We have reviewed the draft report, "Corrosion Behavior Of Low Carbon Steel in High pH Aqueous Media", and have indicated our comments on the enclosed markup. Some are editorial in nature, but others are intended to focus attention on our interest in more specificity as to findings, conclusions and recommendations. Thus:

Corrosion Behavior of Low Carbon Steel in High pH Aqueous Media

Figure 1. Cyclic anodic polarization curve for A27 steel in GR-4 water at 95°C.

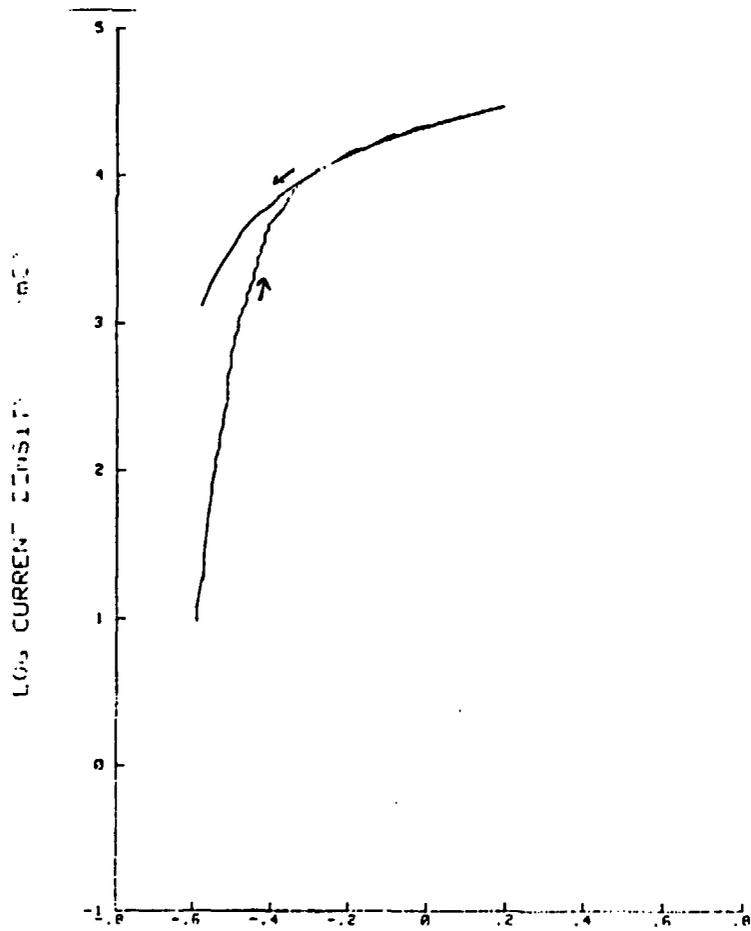
opinion?
of what?
with same smooth.

not a dent

the explanation

Figure 2. Cyclic anodic polarization curve for A27 steel in GR-4 water with basalt and bentonite at 95°C.

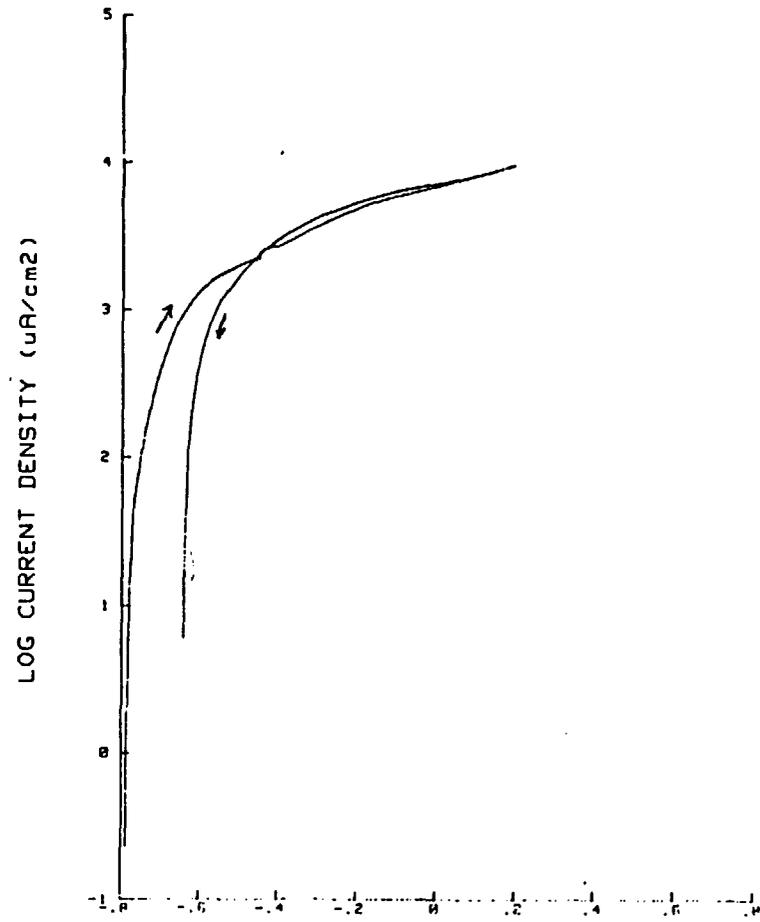
opinion?
should reconcile with Fig 1 explanation

Fig. 3. A27 steel, uncorroded.

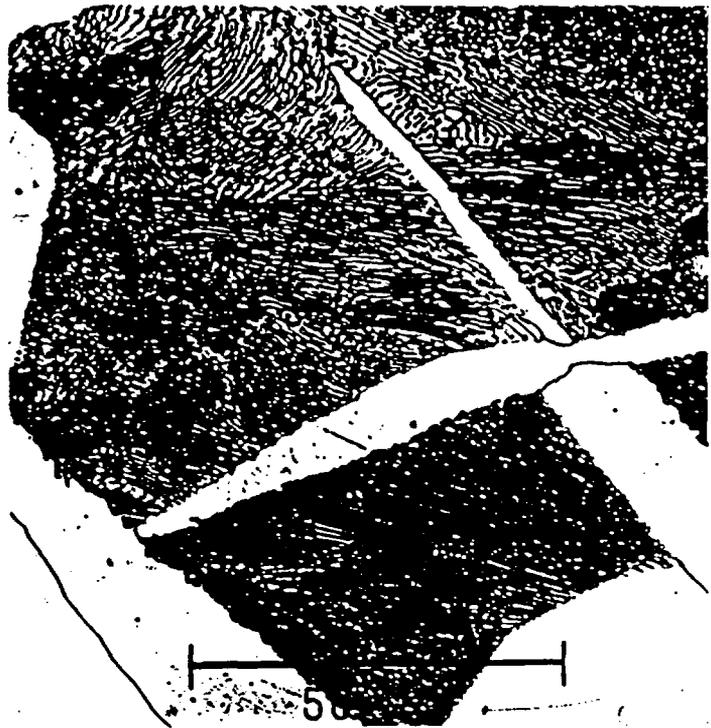
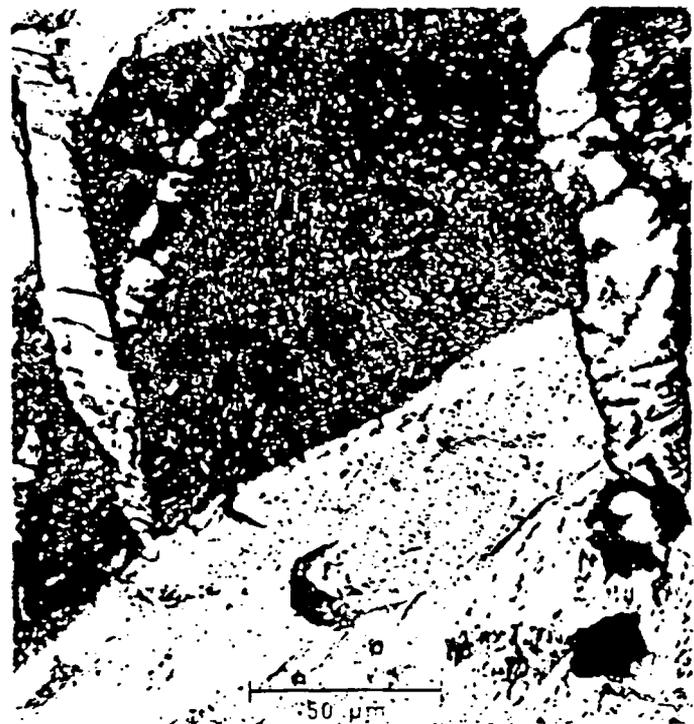
can't see in picture

define pit.
